Reference: H04/0949/93

Description: Demolish swimming pool building and erect new  
 community centre and car parking

Location : Land at former swimming pool Town Dam Lane  
 Donington Spalding Lincs

| date          | scale(s)    |
|---------------|-------------|
| 91 / 13       | 11          |

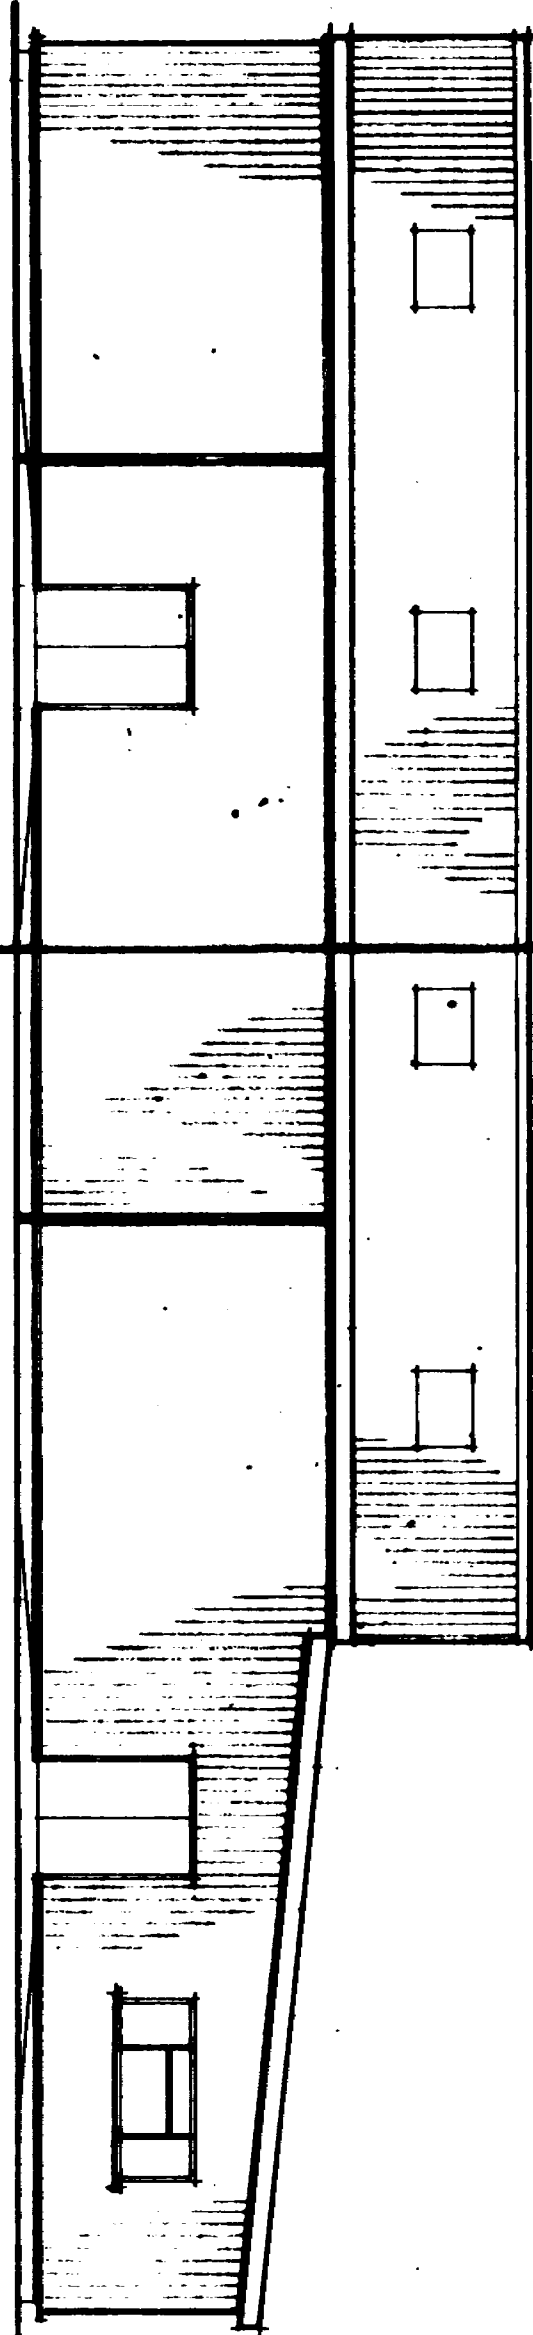
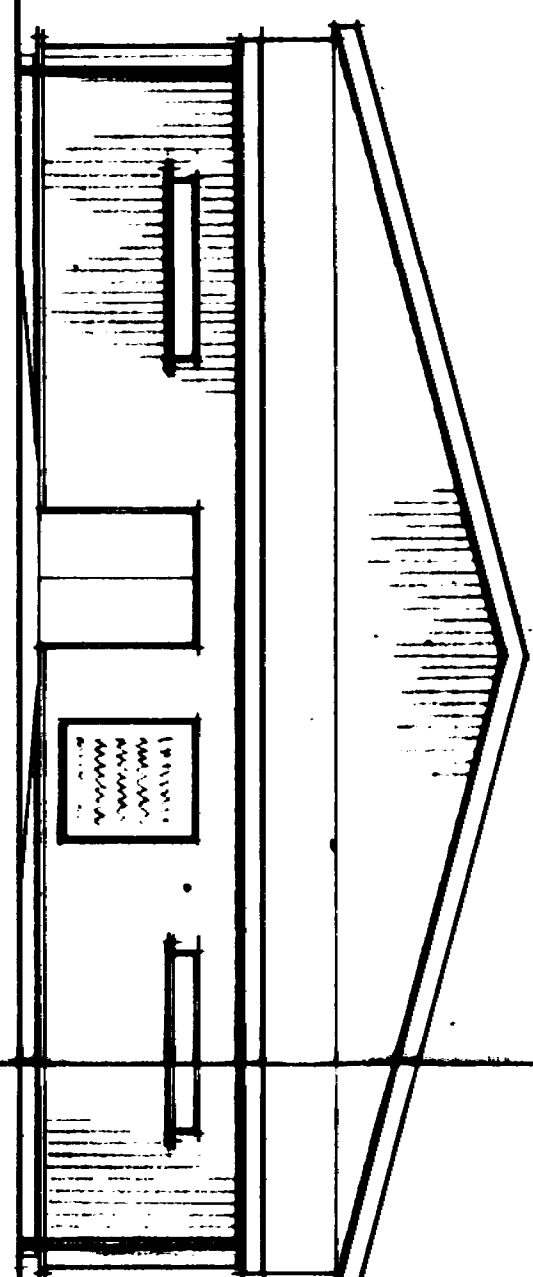
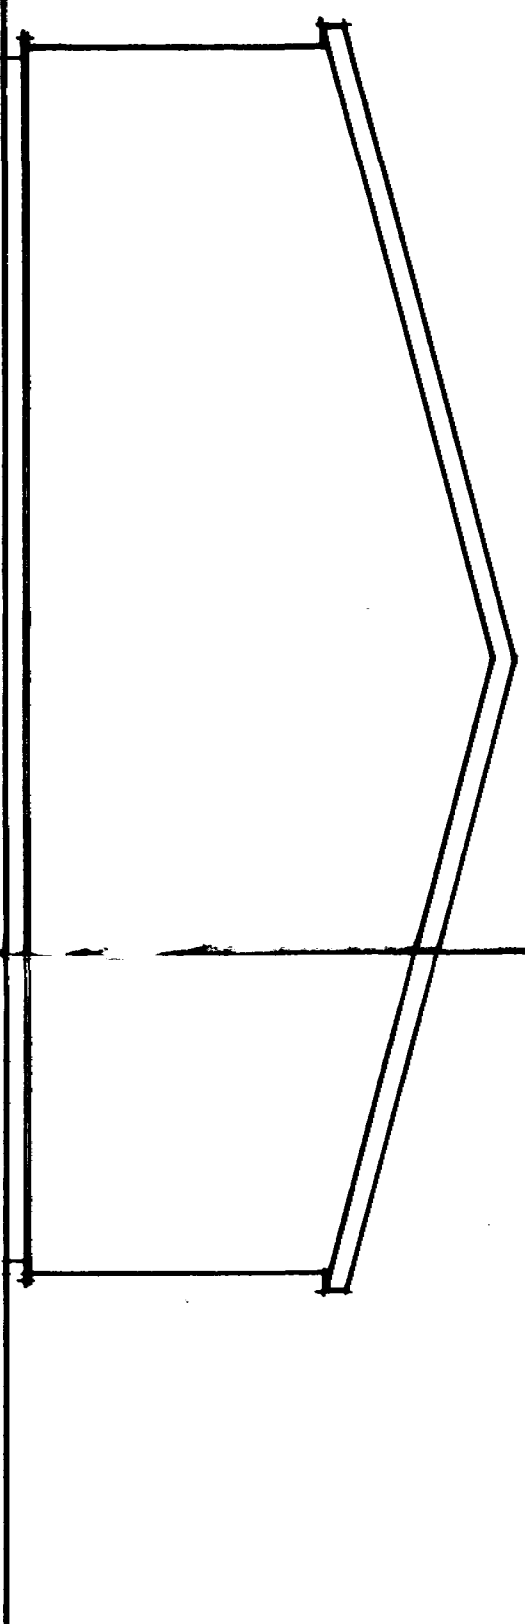
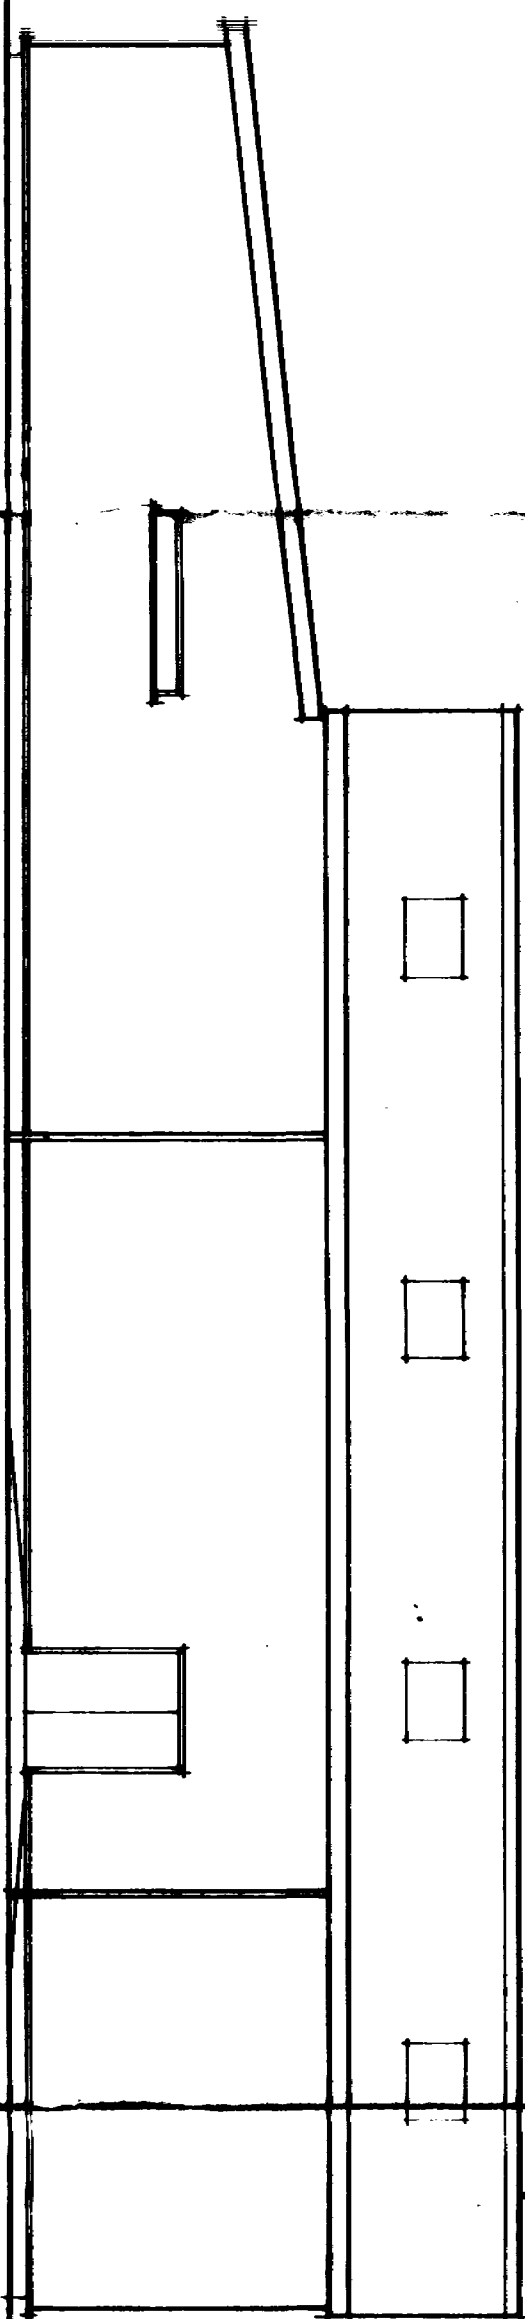
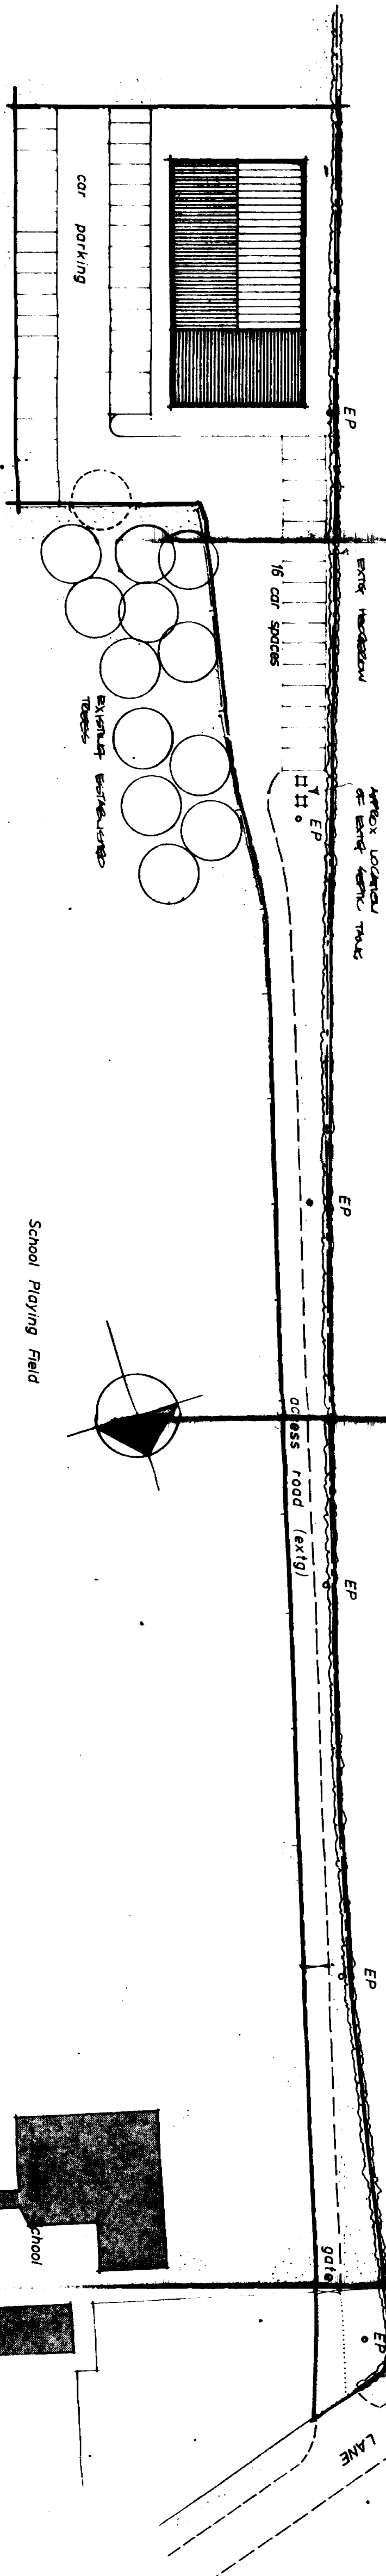
- (1) The car parking is some 17 spaces short  
of the requirements shown in the current  
guidelines
- (2) The access will need to be widened to 4.5m  
for the first 10m from Town Dam Lane  
to allow vehicles to pass at the access
- (3) Paving bays shall be provided along the  
access road to allow vehicles to pass within  
the site.

| date          | scale(s)    |
|---------------|-------------|
| 91 / 13       | 11 A        |

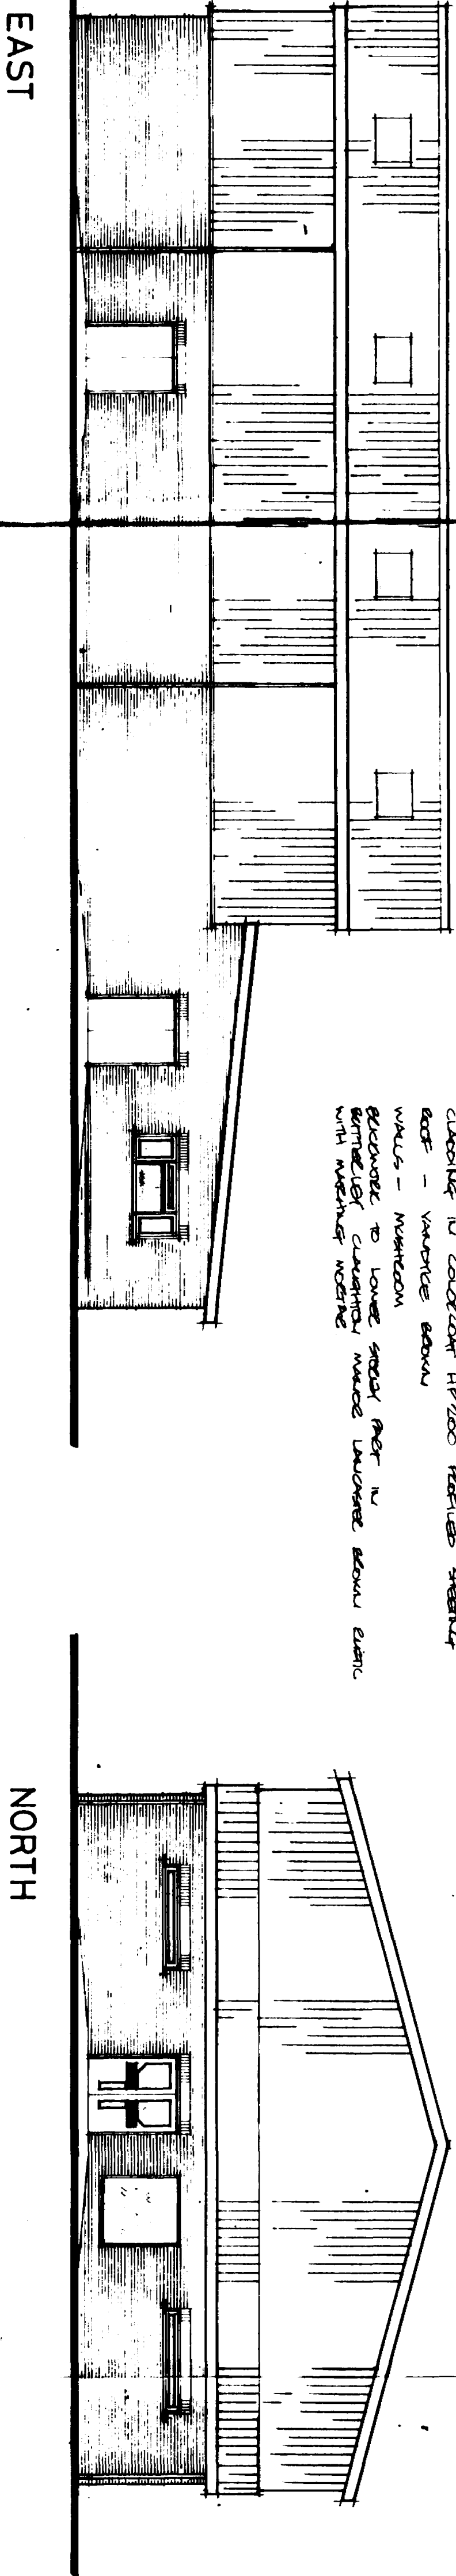
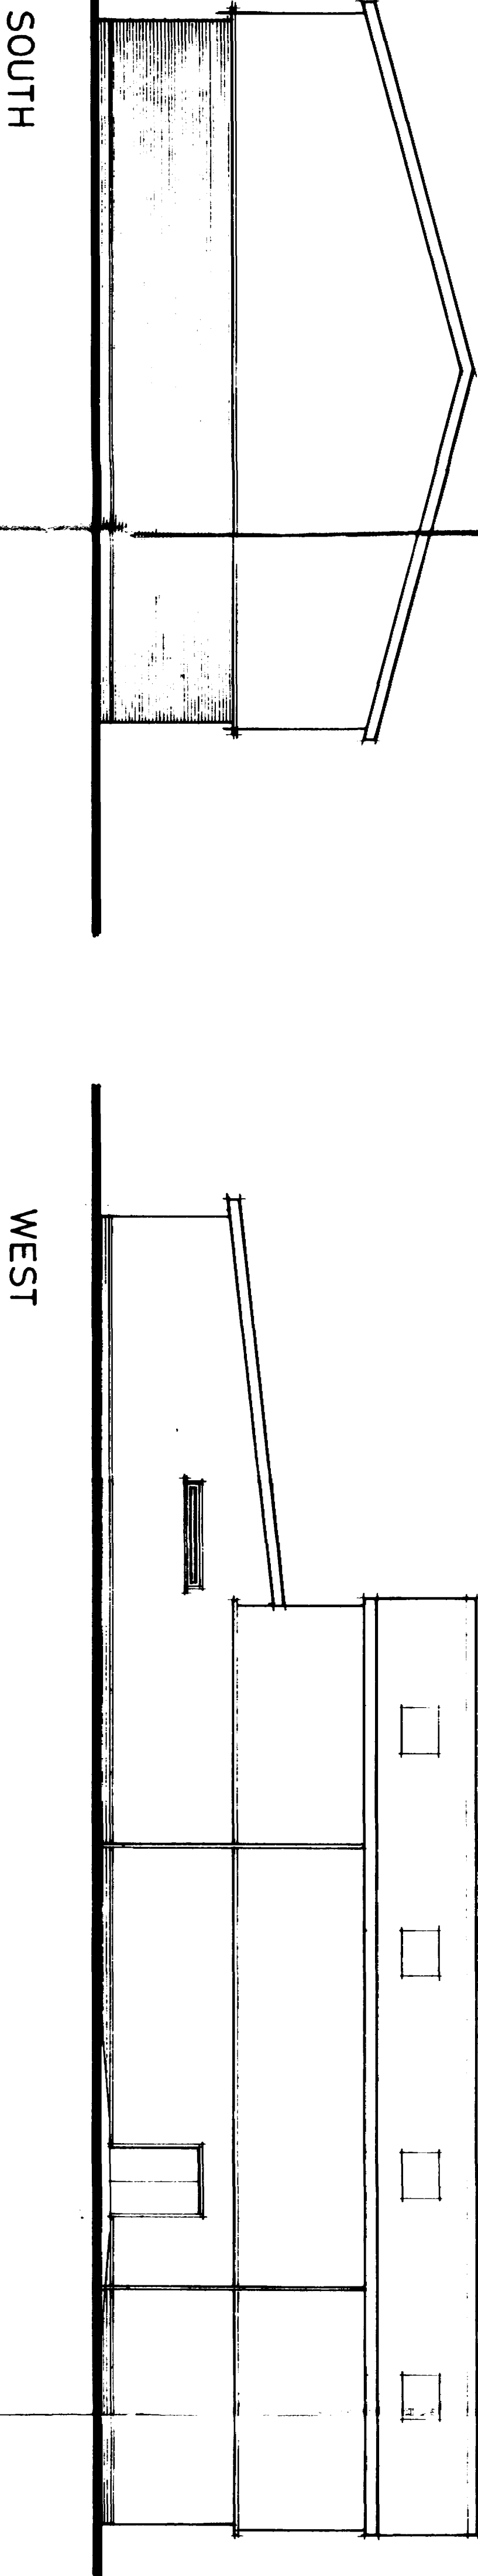
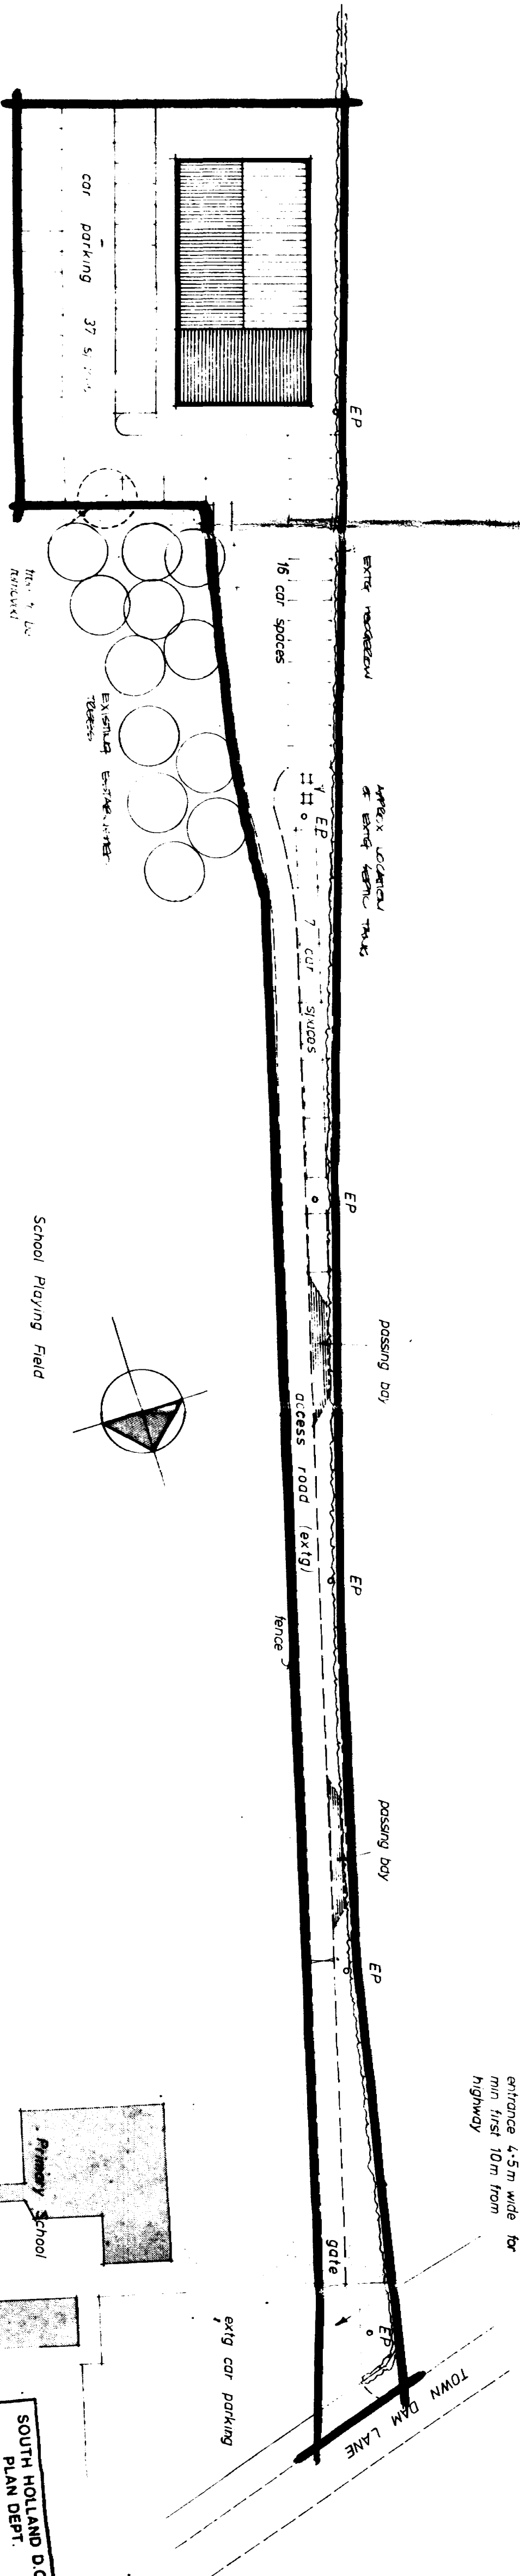
As a separate issue, I am concerned that the external walls of the building will be wholly clad. In my opinion the appearance of the building would be improved if the single storey element was faced in appropriate brickwork. I would welcome your views on this, and request amended plans to incorporate the revisions required by the County Highway Authority.

- 3 Before the use is commenced the access, including the passing bays, shall be laid out and constructed as shown on the amended drawing no: 11A received on 5 November, 1993.

This permission is granted in accordance with the application submitted as revised by Drawing no: 11A received by the Local Planning Authority on 5 November, 1993.
